Re: Revised Work Plan
490 43rd Street, Oakland, California (Blumert Trust)
ACC Project No. 95-6305-001.01

**REVISED WORK PLAN
ADDITIONAL SITE INVESTIGATION AND REMEDIATION**

**490 43RD STREET
OAKLAND, CALIFORNIA**

| Title: Boring Location Map 490 43rd Street Oakland, California | |

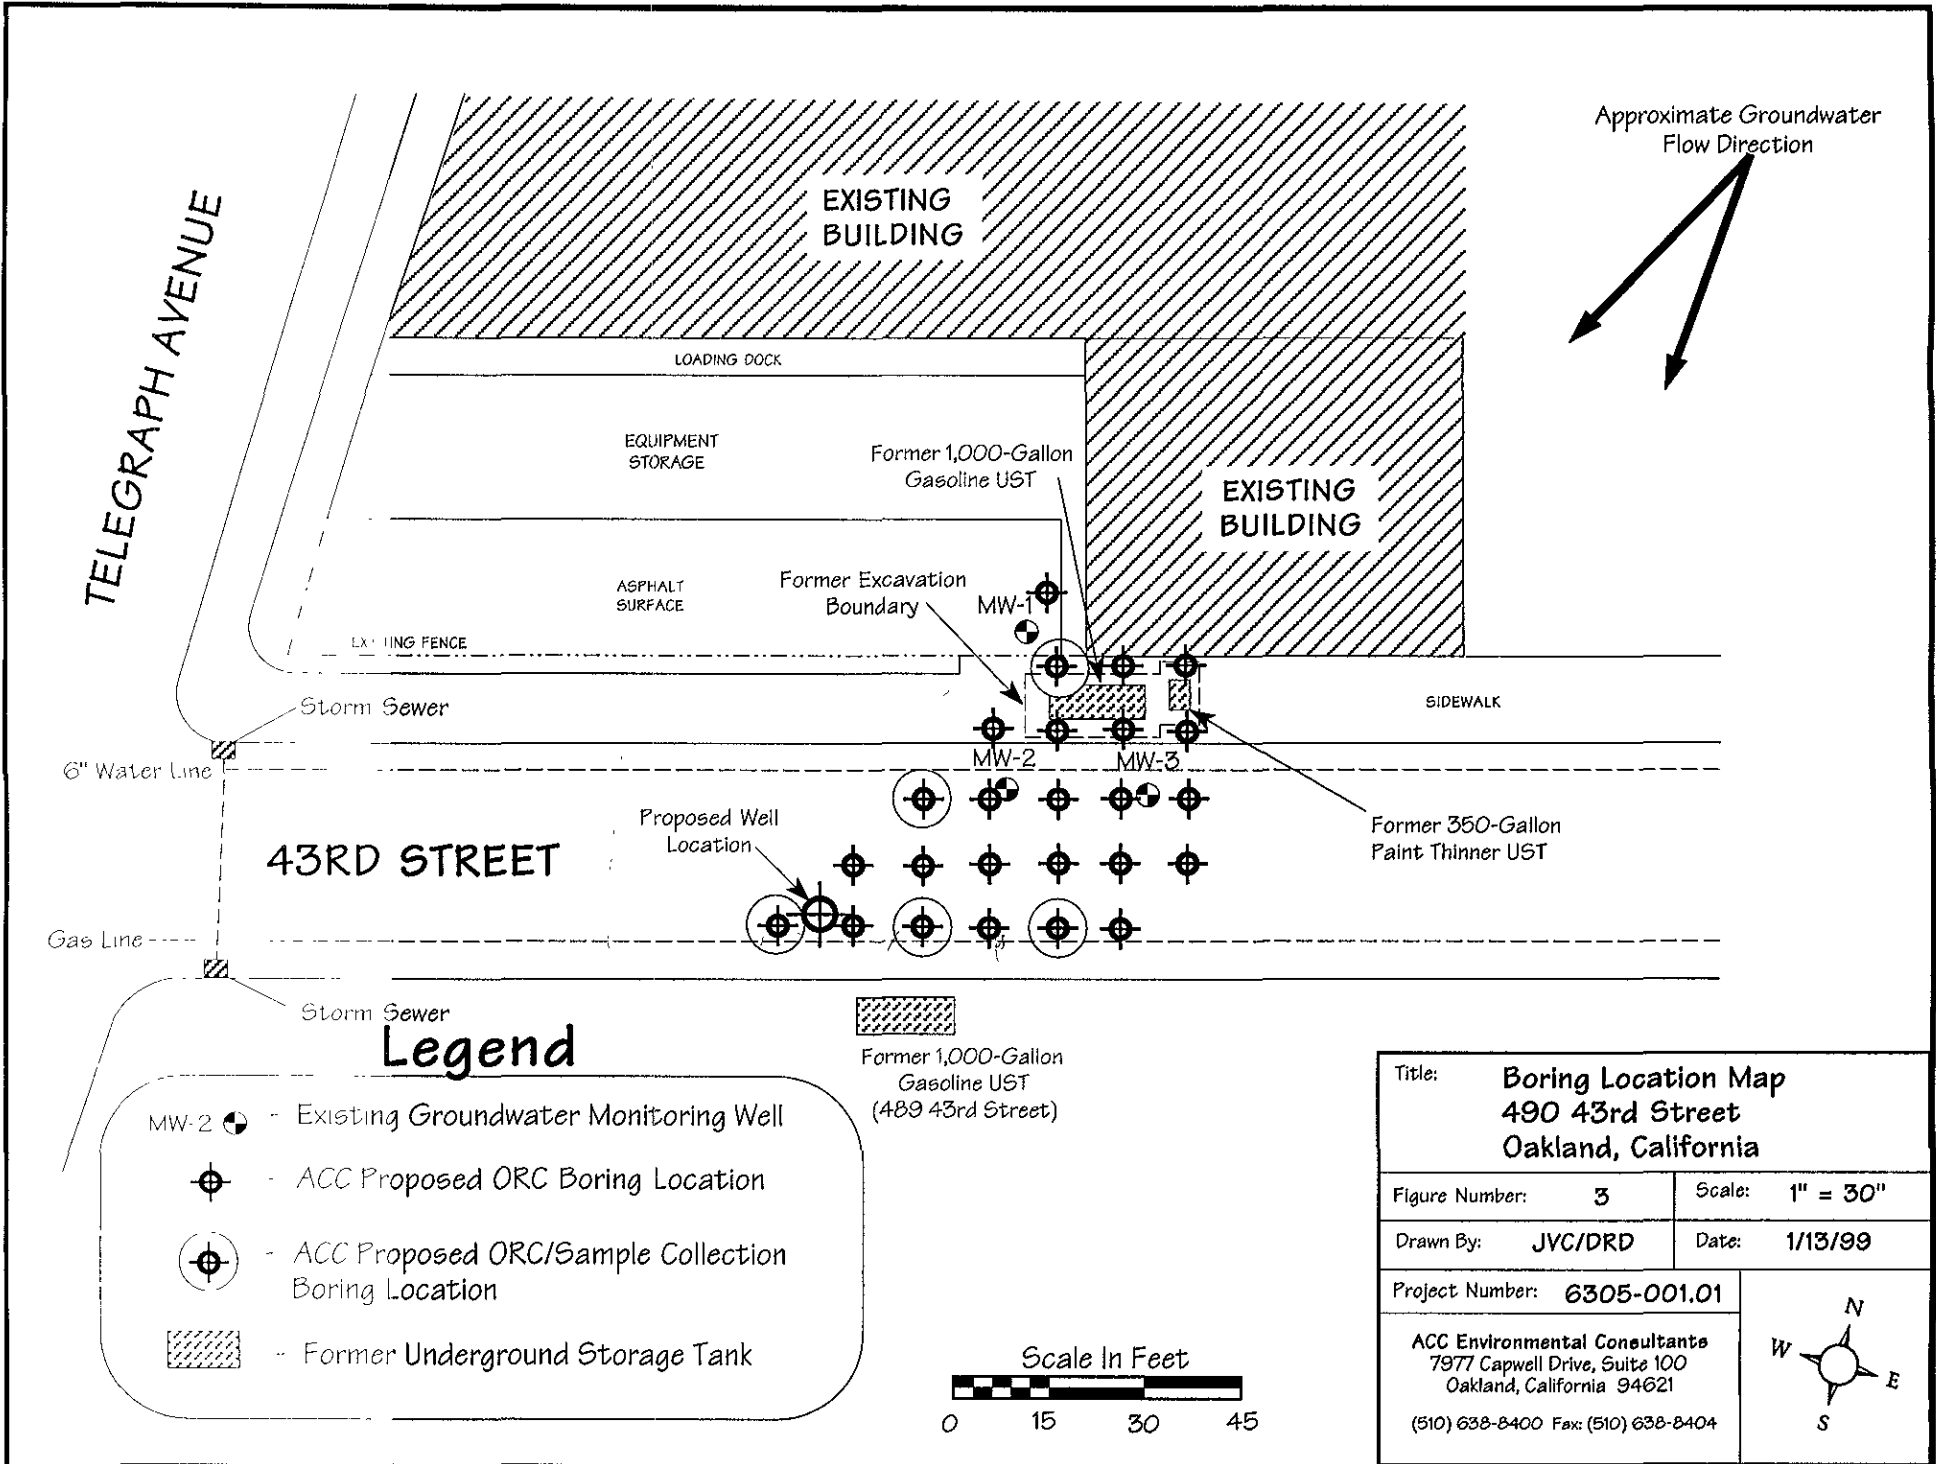
why collect a soil sample from cap fringe?

Must be encountered during boring Sched for 7' into solid zone
